Appendix 2: CONSULTATION, FEEDBACK AND RESPONSES

Site Specific Management Plans 005 + 006 - Otaihanga North and South [COMBINED]

MacKays to Peka Peka Expressway

COMMENTS ON PRELIMINARY ISSUE SSMP5+6:OTAIHANGA

PROPOSED PLAN- OTAIHUNGA ROAD BRIDGE- 1:500@A3

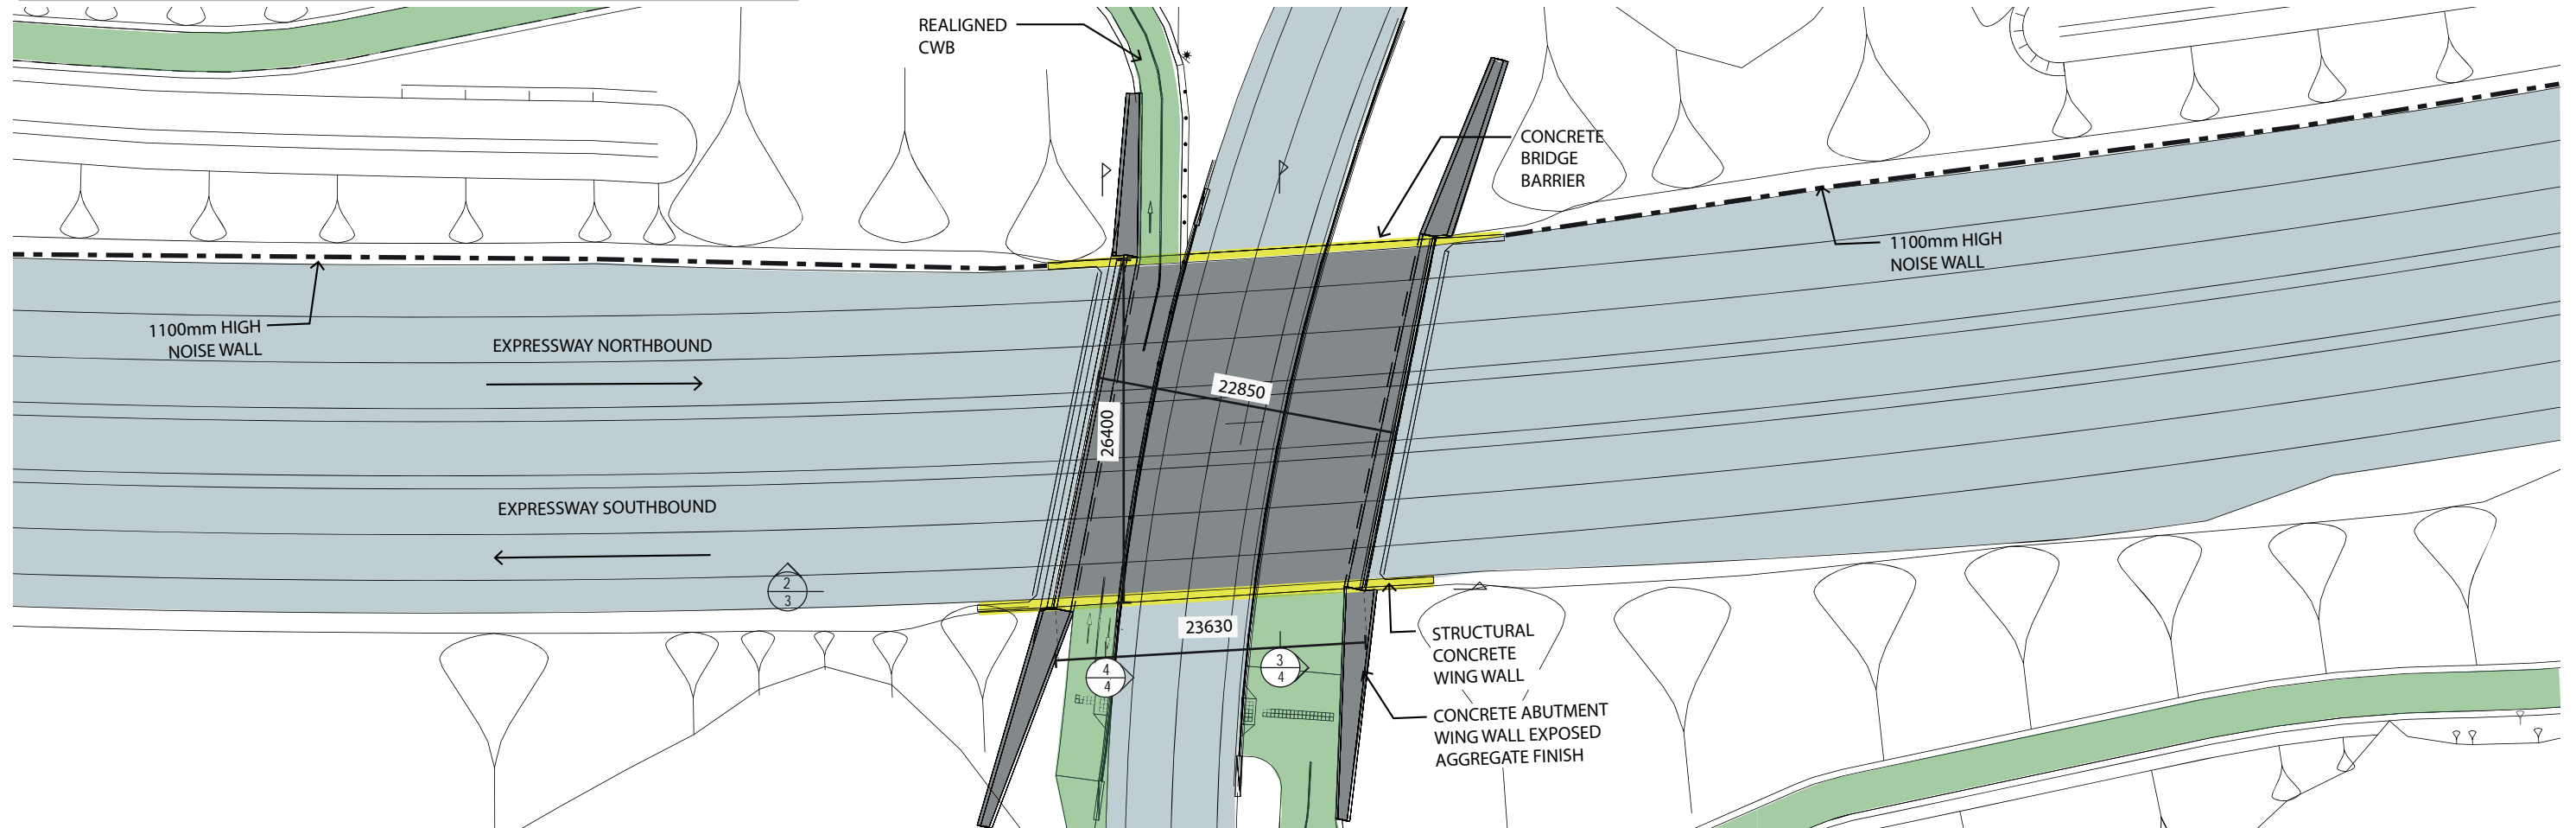
JW	ULDF: 5.11.2: Remove <i>Vitex lucens</i> from Planting Schedule - not a local species and considered a weed	Sheet 22	Agree, SSMP amended to delete this species.
		JW	ULDF 5.7.3: Direct sight lines along local roads to and under bridges to be finalised		Sight lines are shown in the SSMP on Sheet 6.
		JW	ULDF 5.7.4: Details to be provided on the scale and shape of abutments to provide an openness along with consented and proposed abutment forms and gradients		Spill-through abutments are provided with abutment angle reduced to 70 degrees, refer Appendix 3.

| <ol style="list-style-type: none"> 1. Change in position of crossing 2. Width of bridge 3. More detail provided for abutment treatment 4. Cycleway integration to local road | <ol style="list-style-type: none"> 5. Concrete noise walls 1.m high (same height as bridge barrier) |

| <ol style="list-style-type: none"> 1. Improve sight distance on local road and cycleway 2. Improve sight distance on expressway 3. Extended bridge abutments tie in with and retain the proposed embankment. Designed as one long continuous element they | <ol style="list-style-type: none"> lead pedestrians though and under the bridge connecting one side to the other. 4. To improve connection of cycleway with local road 5. Noise mitigation |

2. PROPOSED ELEVATION - OTAIHANGA ROAD BRIDGE EAST ELEVATION (LOOKING WEST) - 1:200@A3

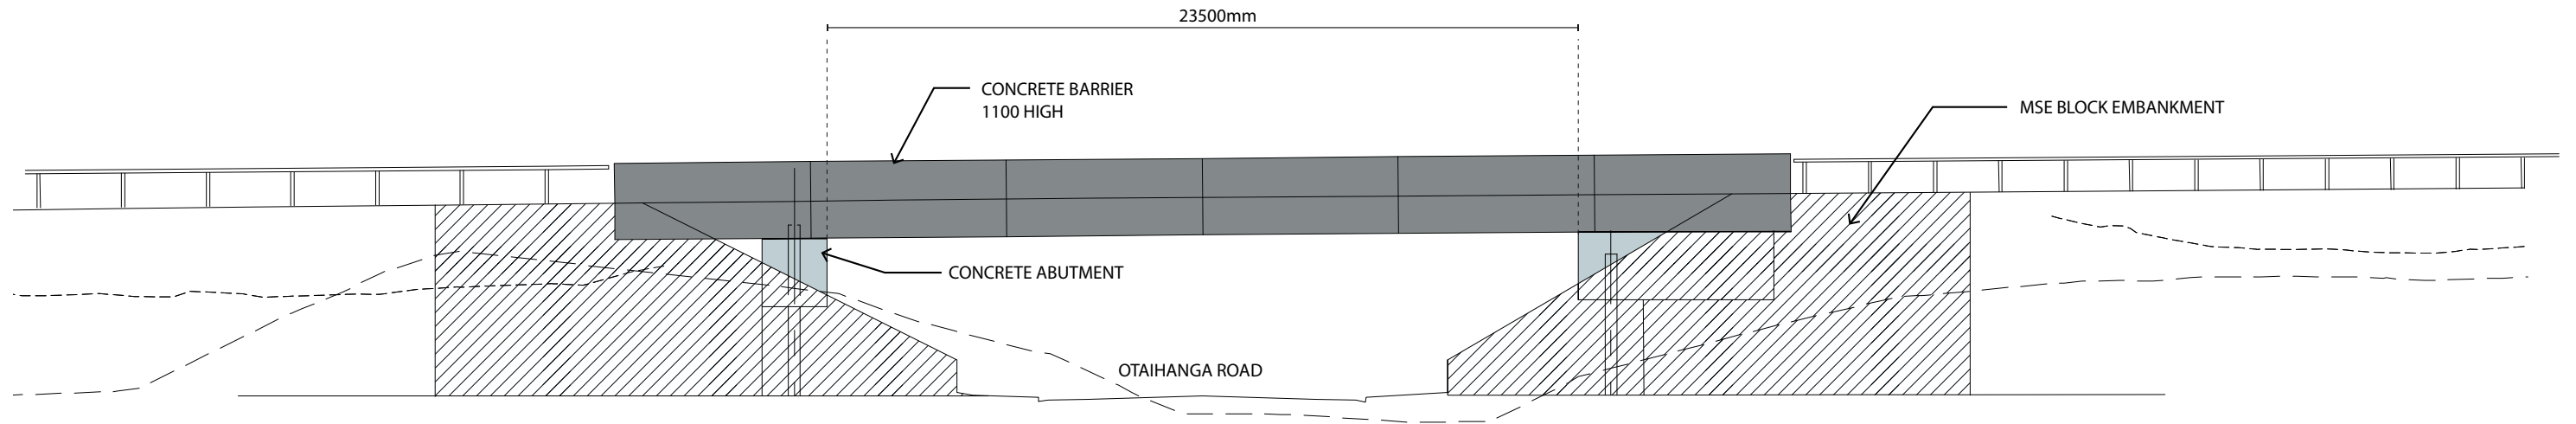
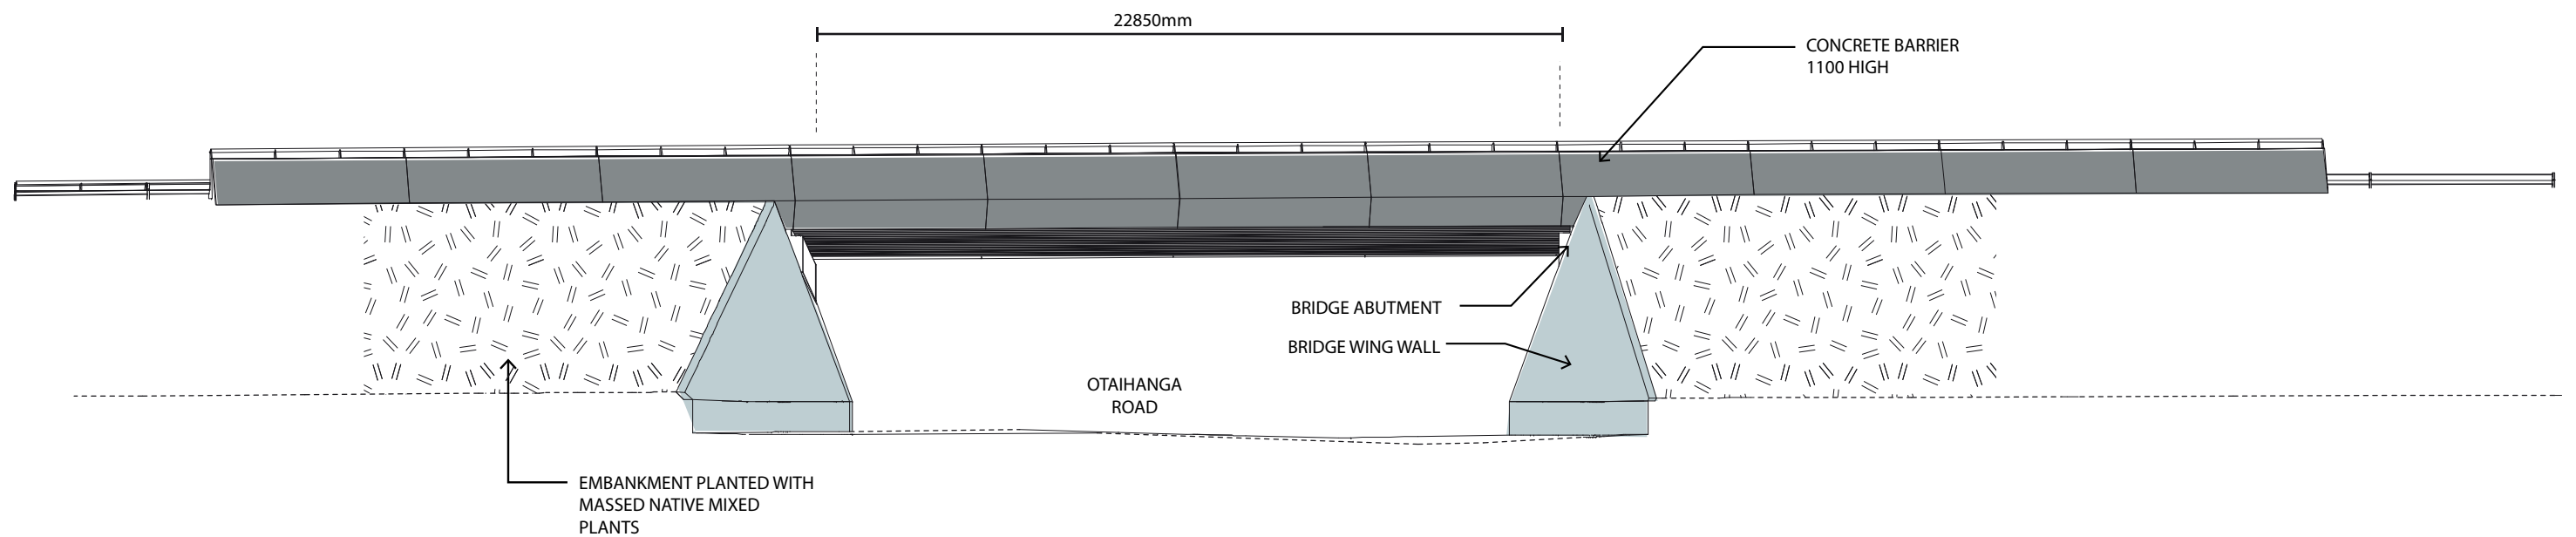
JW	ULDF 5.7.5: Requires detail on how gabion forms and precast panels with stone facing will be integrated under bridges and on transition from abutments to landscape context.		Gabion walls replaced with pre-cast concrete panels with exposed aggregate finish. Gabion walls used as a transition marker at CWB intersection. These will tie into side of bridge abutment.
		JW	ULDF 5.7.7: No detail has been provided on how the spaces beneath bridges will be lit to enhance the quality of the space including natural light penetration		No lighting will be installed under bridges in rural areas (including Otaihanga Road bridge). However, there will be two pole lights at the end of the cycleway at the intersection with Otaihanga Road.
		JW	ULDF 5.7.12: Prefer Option 2 on Sheet 12 over Option 1. Page 12 notes that "a wide space of 6.0m width is provided for CWB on the south side of Otaihanga Road under the bridge", should this read 3.3m?	Sheet 12 and Page 12	Confirm that this should read 3.0m (minimum).

1. Local road reserve width increased
2. On road cycleway provided
3. Abutment steepened
4. Abutment treatment identified. Gabions removed

5. Footpath widened to 3m south of Otaihanga Road from under the bridge

1. Improve sight distance, increased opening under bridge
2. To improve connection of cycleway with local road
3. To provide wider road for sight distance without increasing bridge spans and depth of beams/size of barriers

4. Gabion baskets removed to allow for a wider footpath/ cycleway on south side of Otaihanga road
5. Southern footpath to form part of CWB. Consistent width required
